REMARKS

Rejection under 35 U.S.C. § 102(e):

FIG. 5E

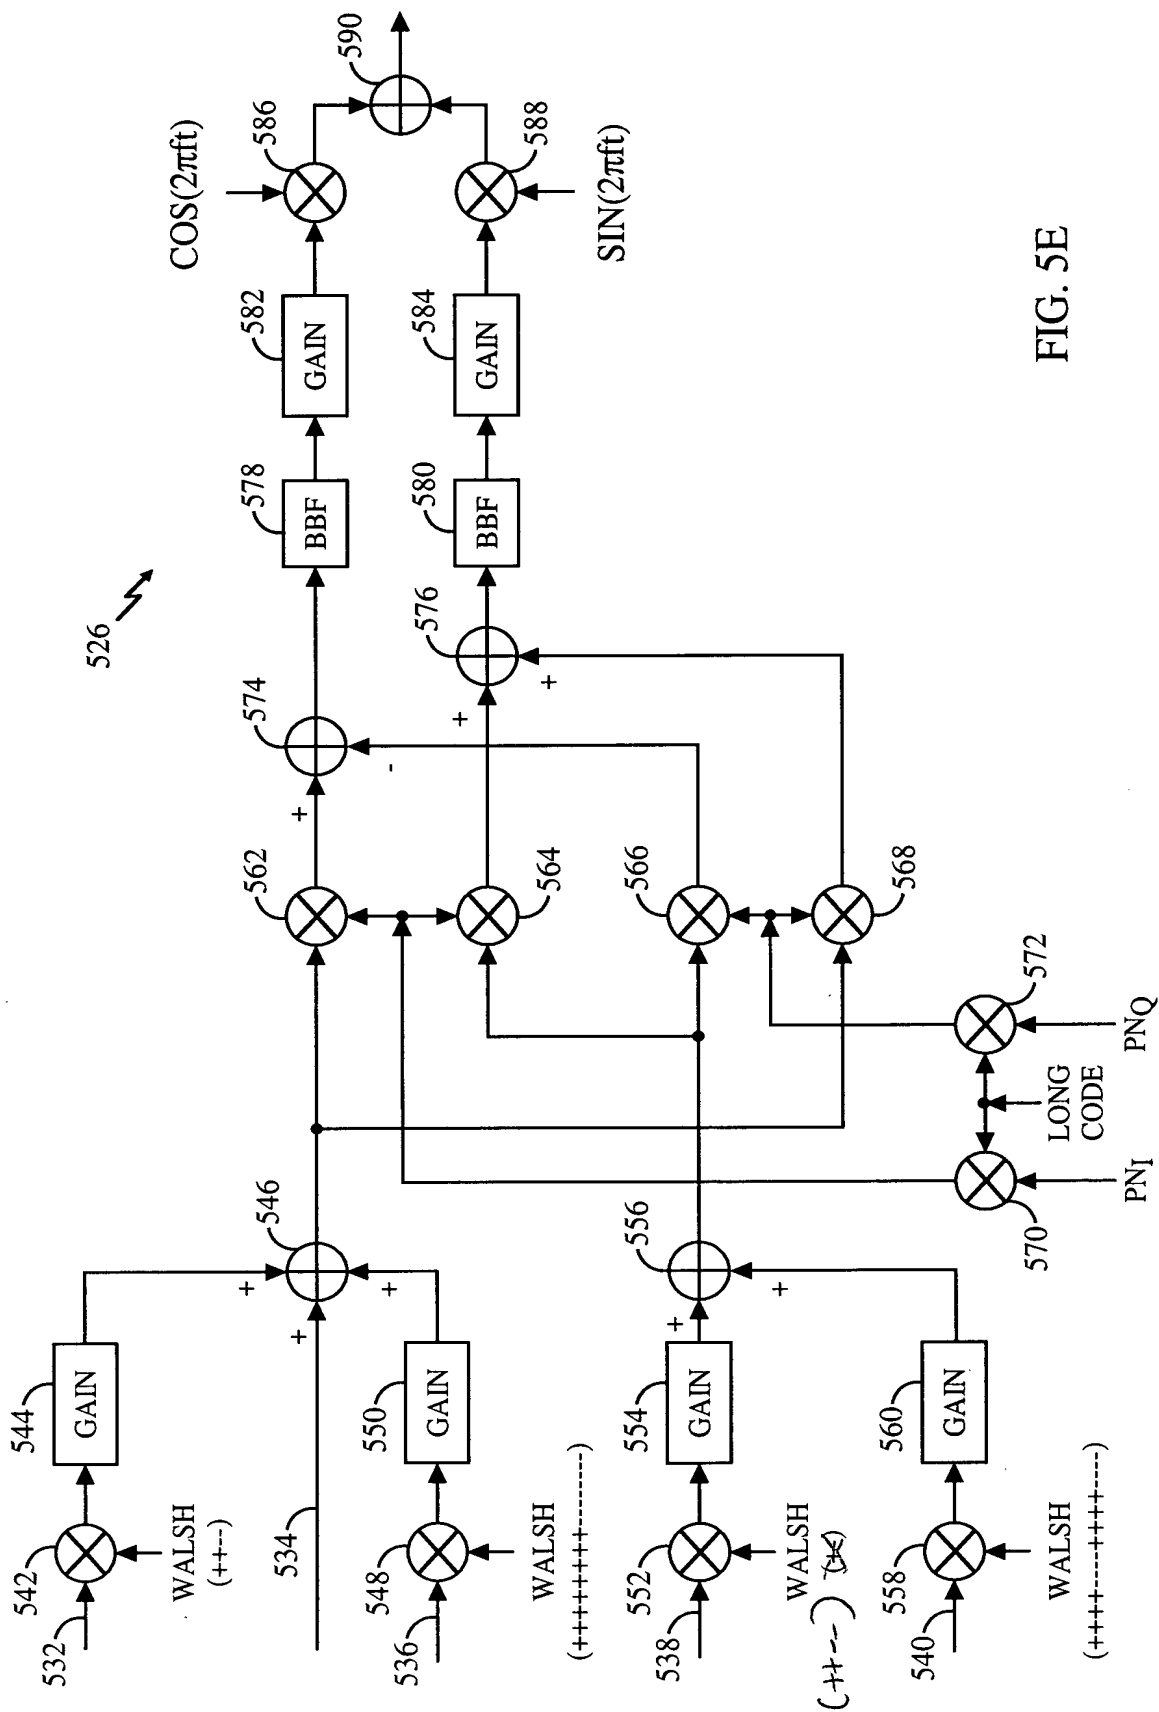
The drawings are objected to because Fig. 5e part number 552 should have "Walsh (++--)" not "Walsh (+-)" so as to match page 25 line 23 and page 24 line 1. Applicants amend Fig. 5e to incorporate Examiner's recommended corrections.
